No. 156 - 164 Gray's Inn Road Areas and Minor Amendments September 2022

14093_AHMM-ZZ-XX-RP-A-00005 Rev 01

Introduction Purpose and Contents

S73 Scheme 3. Incorporating changes to comply with updated guidance since 2017

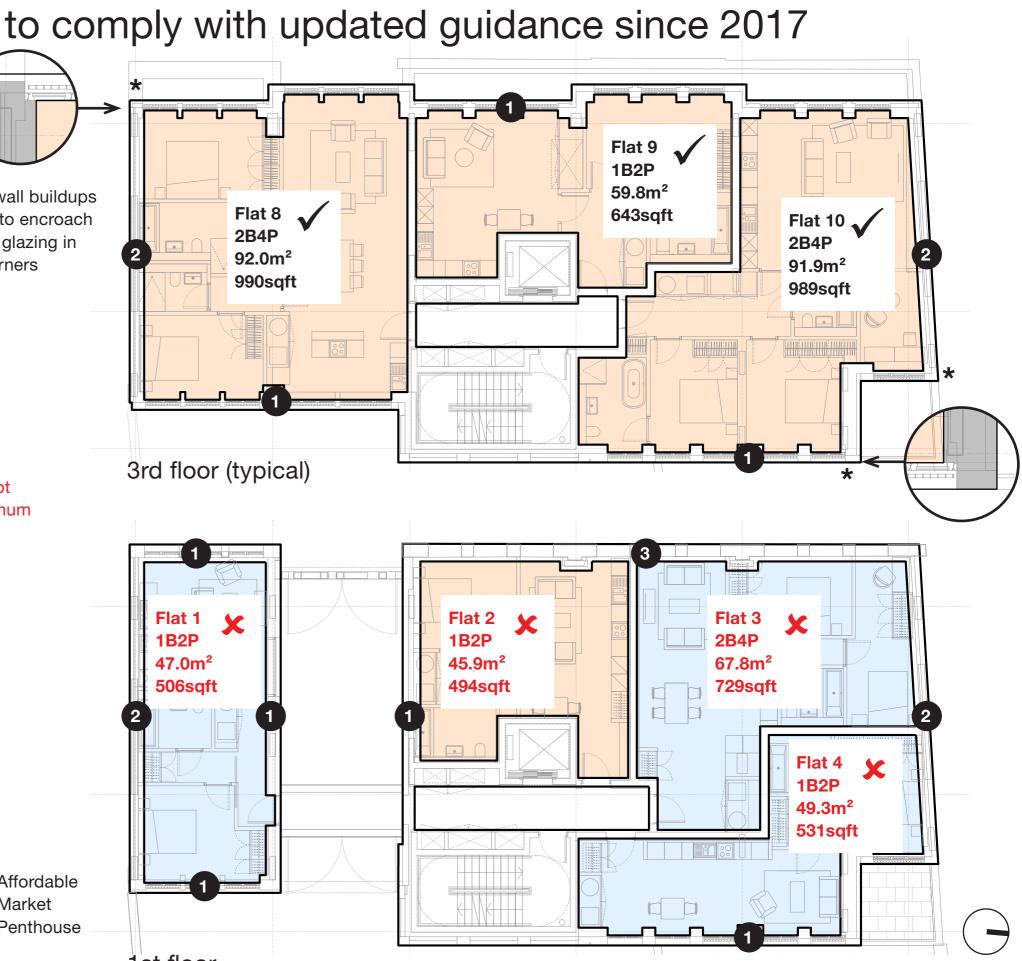
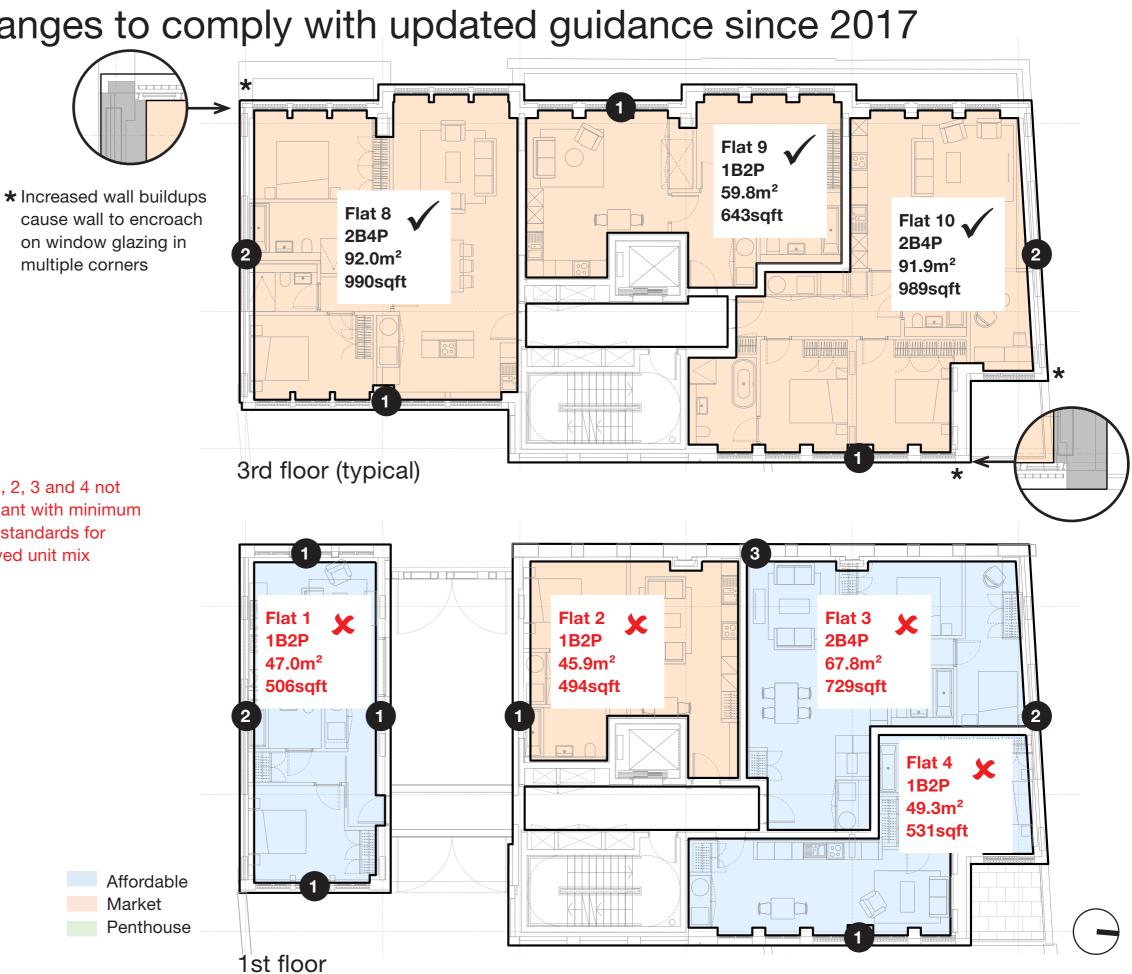
Insulated separating party walls 2 to comply with Part L and SAP calculations

Insulated retained facade to comply with Part L and SAP calculations

Flats 1, 2, 3 and 4 not compliant with minimum space standards for approved unit mix

Proposed Scheme Minor changes to maintain minimum area standards

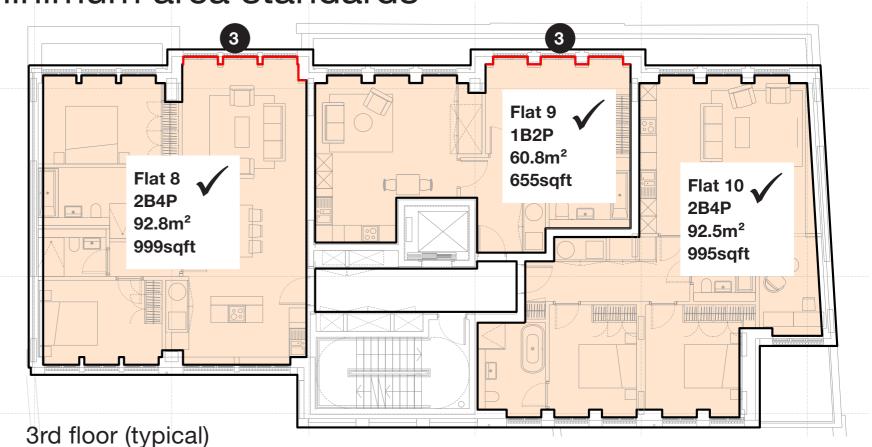
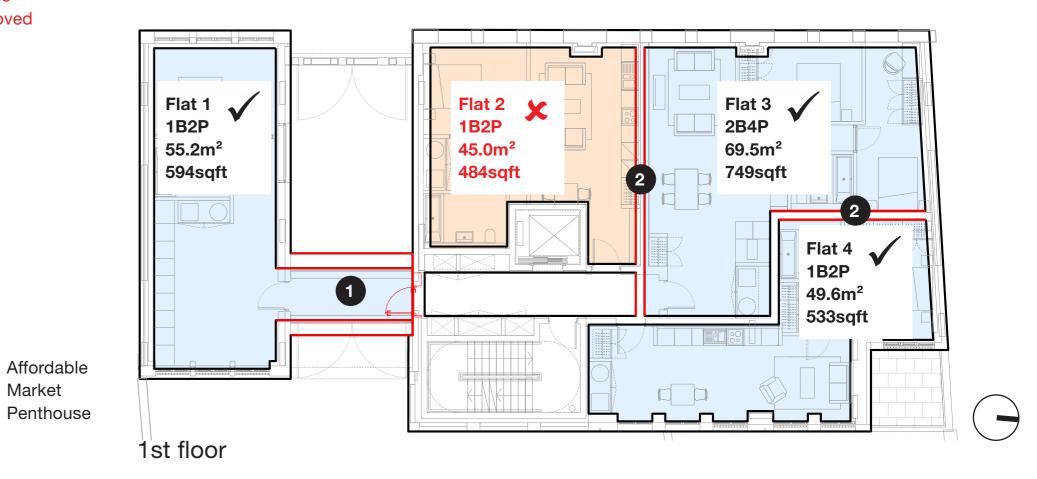
Bridge link absorbed into Flat 1 providing lobby entrance into flat. Details on following pages

- Party walls revised to bring 2 affordable units into compliance with minimum area standards
 - Mid piers and windows on projecting bays shifted forward by 100mm. Main facade line maintained. Details in section 5.2 Front Facade.

Flat 2 not compliant with minimum space standards for approved unit mix

5. Proposed Scheme Details5.1 Layouts - Flat 1 design development

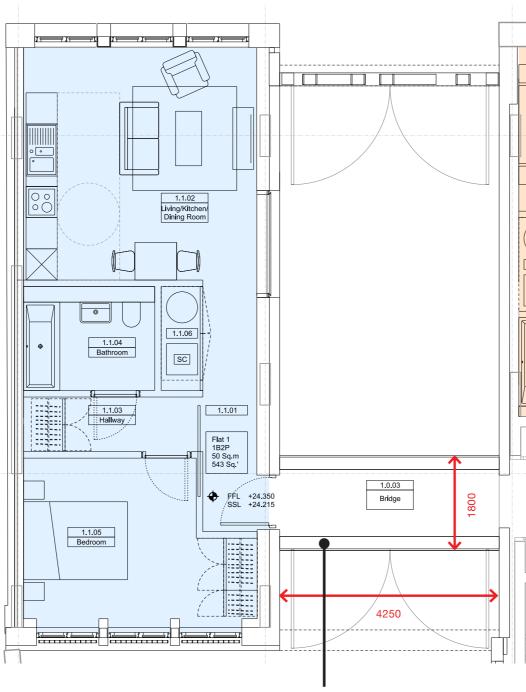
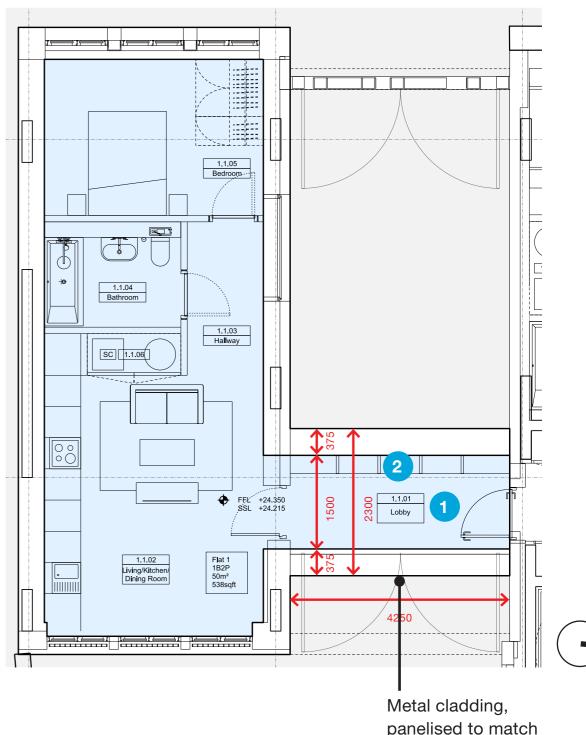
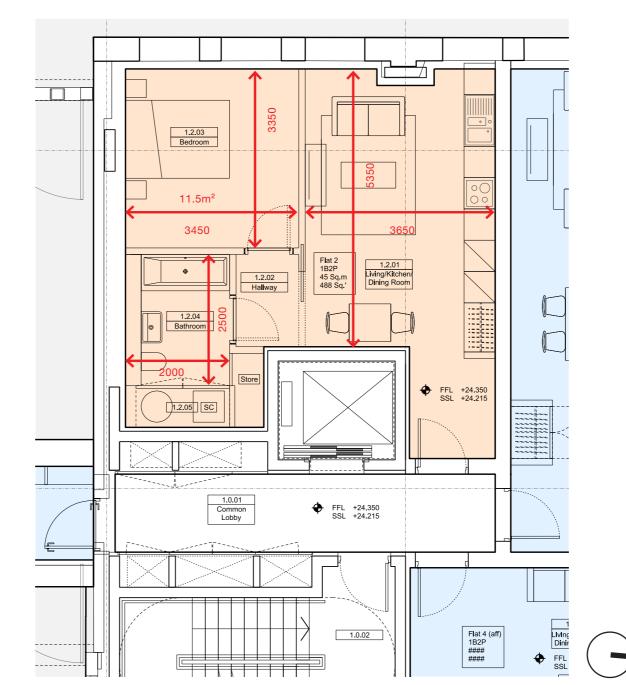
Of the three affordable flats in the scheme, flat 1 suffers the greatest area loss due to the technical updates. To bring this flat back into compliance with minimum space standards the team proposes re allocating the bridge link that leads to Flat 1 from communal circulation space to private space for Flat 1.

To preserve tenant privacy and maintain thermal performance compliant with Part L the glazed curtain wall here will be replaced with metal cladding, finished and panelised to match the existing window arrangement. Daylighting within the passageway will be largely unaffected due to its orientation away from sun and the density of surrounding development. External lighting remains the same.

New hallway creates better arrival and circulation into the flat

Additional storage can be created for the unit
